Proposal for amendments to Regulation No. 13 (Heavy vehicle braking)

The text reproduced below was prepared by the experts of the informal working group ACV to be inserted into Regulation No. 13. This is to produce:

Figure A: Point-to-point connection ECU Tractor (1) and ECU Trailer (9) when Fifth Wheel is closed

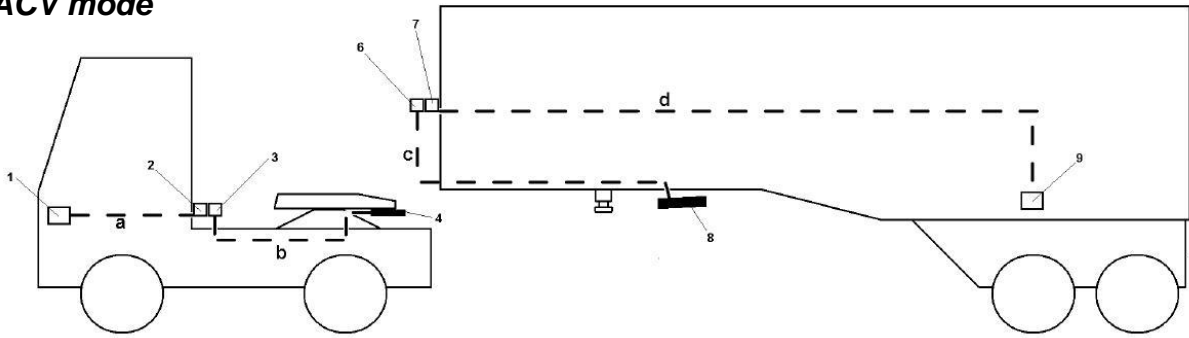
ACV mode: No helix cables installed, Connection between 3 and 6 when 4 and 8 are connected (i.e. fifth wheel coupled)

Figure B: Point-to-point connection ECU Tractor (1) and ECU Trailer (9) when Fifth Wheel is closed

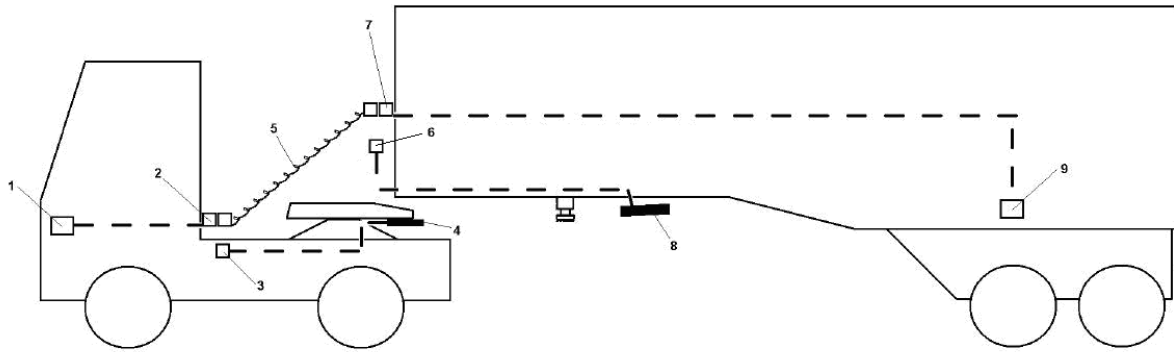
Manual mode: Helix cables installed, Connection between 3 and 6 as 4 and 8 are not connected

**Figure C: Point-to-point connection ECU Tractor (1) and ECU Trailer (9) when Fifth Wheel is closed
Helix cables installed, Line 3 to 4 is not connected**

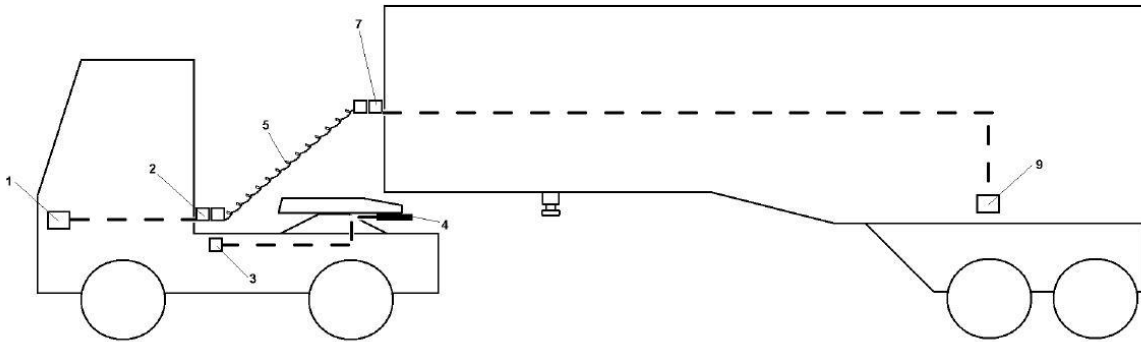
Manual mode A (only the truck ACV equipped)

**Figure D: Point-to-point connection ECU Tractor (1) and ECU Trailer (9) when Fifth Wheel is closed
Helix cables installed, Line 6 to 8 is not connected**

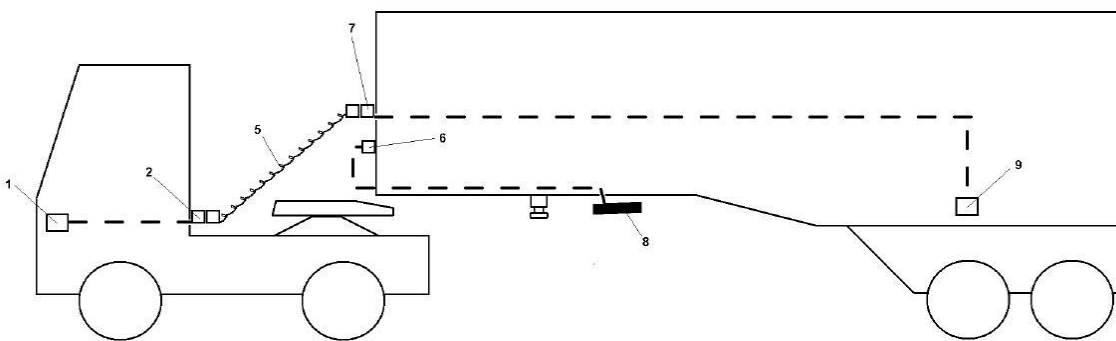
Manual mode B (only the trailer ACV equipped)
